### **REMARKS**

APPL. NO. 09/903,262 AMDT. DATEDET JANUARY 27, 2004 Reply to Office action of September 9, 2003 MARKED-UP DRAWINGS

### MARKED-UP DRAWINGS

FIG.1

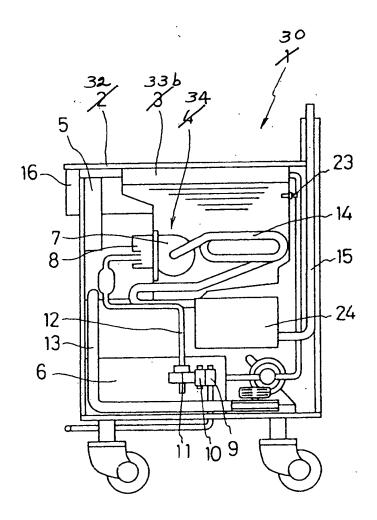
The Examiner states that the drawings fail to show a right and left oil vessel (see page 6, last paragraph of instant specification). Applicant has amended on page 5 the description of FIG. 1 to state that "FIG. 1 is a side elevational view of a fryer" so as not to suggest that all parts of the figure can be seen in FIG. 1. Applicant has similarly amended line 16 on page 6. Therefore, Applicant believes that it is not necessary to actually show both left and right oil vessels 33a, 33b. FIG. 1 is a side elevational view showing the right oil vessel. The specification does not state that the left and right oil vessels 33a, 33b are shown in FIG. 1.

The Examiner states that the drawings are objected to because they do not include the reference sign for element 23 (on page 8). However, Applicant wishes to point out that element 23 (temperature sensor) is shown in FIG. 1.

# JAN 3 0 2004 FIG. 3

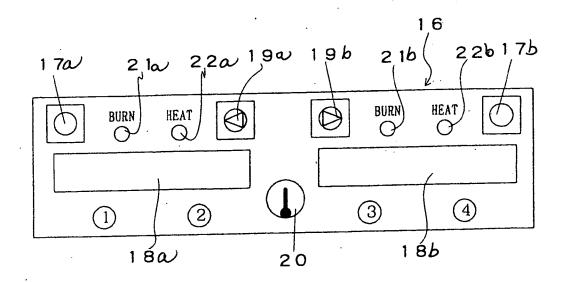
The Examiner states that the drawings are objected to as failing to comply with 37 C.F.R. 1.84(p)(4) because reference character "1" has been used to designate all of a commercial fryer, a cooking start switch and a specific mode selection screen. Applicant wishes to point out that the reference character "1" now refers to only the cooking start switch 1 in the figures. The commercial fryer reference character is changed to 30, and the special mode selection screen (on page 10, line 2) is now referred to as 1-1 and marked accordingly in FIG. 3A.

The Examiner states that the drawings are objected to because they do not include the reference signs mentioned in the description: screen 2-1 and screen 2-2. Applicant has added reference signs 2-1 to FIG. 3(B) and 2-2 to FIG. 3(C).

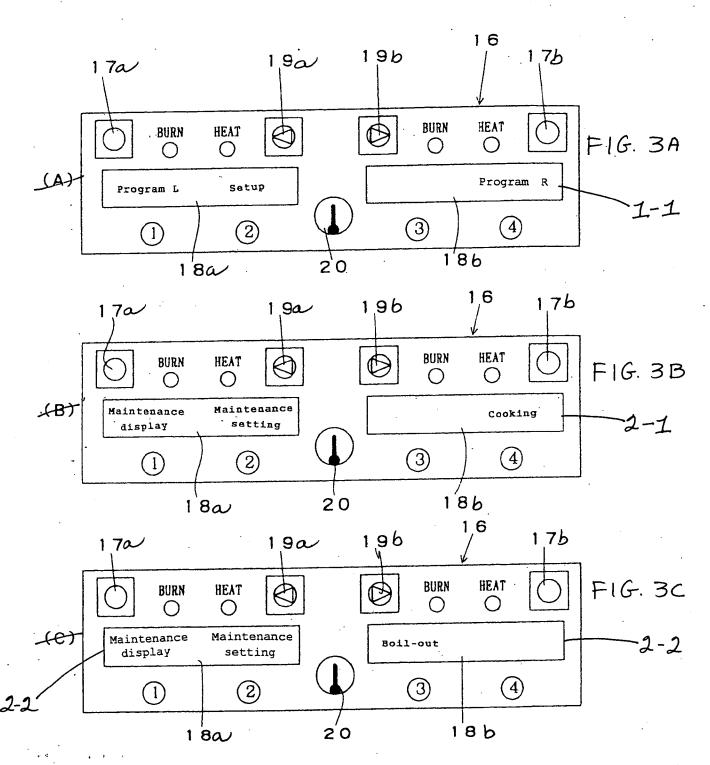
The Examiner states that FIG. 2A, 3B, 3C, 4A, 4B, and 4C are not clearly labeled. Applicant has clearly labeled such figures which are marked-up in red for the Examiner's approval.

The Examiner states that FIG. 4C is not described in the instant specification. Applicant has amended the Specification on page 11, line 22, adding "as shown in FIG. 4C" after "For example, when "MON" is displayed".

The Examiner states that in the BRIEF DESCRIPTION OF THE DRAWINGS on pages 5-6, FIGS. 4A, 4B and 4C are not adequately distinguished. Applicant has amended the description of FIGS. 4A, 4B and 4C to be specific and distinguishable. FIG. 4A illustrates a display of an operating panel when a maintenance period may be set. FIG. 4B illustrates the display when a maintenance frequency is set and FIG. 4C illustrates the display when a day of the week of the maintenance period is set. Applicant believes that FIGS. 4A, 4B and 4C are now adequately distinguished.

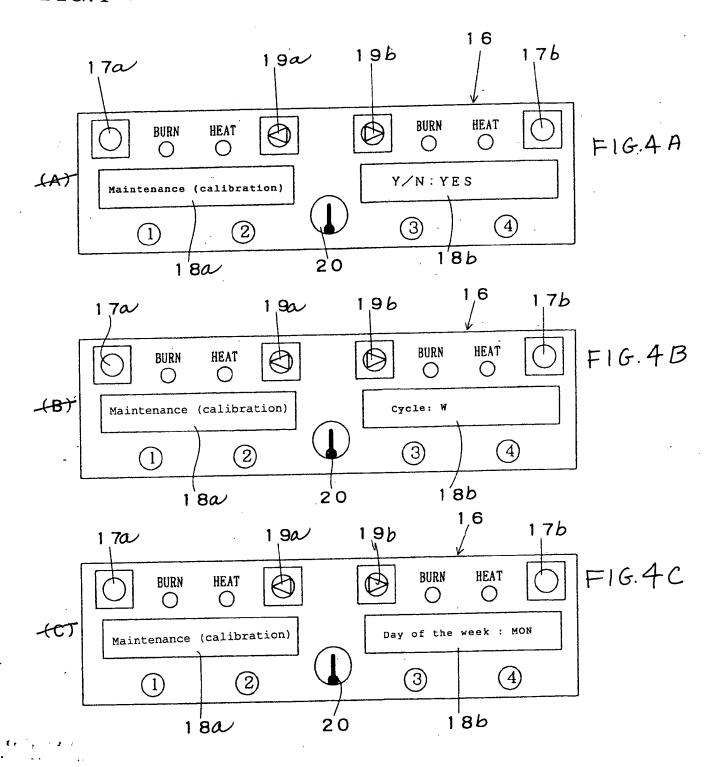
The Examiner states that reference characters 3, 17, 18, 19 have been used to designate both left and right components. To resolve this problem Applicant has amended the specification changing such references to 33a, 33b, 17a, 17b, 18a, 18b and 19a, 19b respectively to indicate the left and right components.

The Examiner states that the drawings are objected to because the reference numbers 2, 3, and 4 each designate a switch and another element in the invention. The reference numbers 2, 3, and 4 will continue to reference the switches 2, 3, 4 and new reference numbers are assigned to previous conflicting elements as follows: casing 32, oil vessels 33a, 33b and pulse burner 34. The specification and figures are amended herein accordingly.
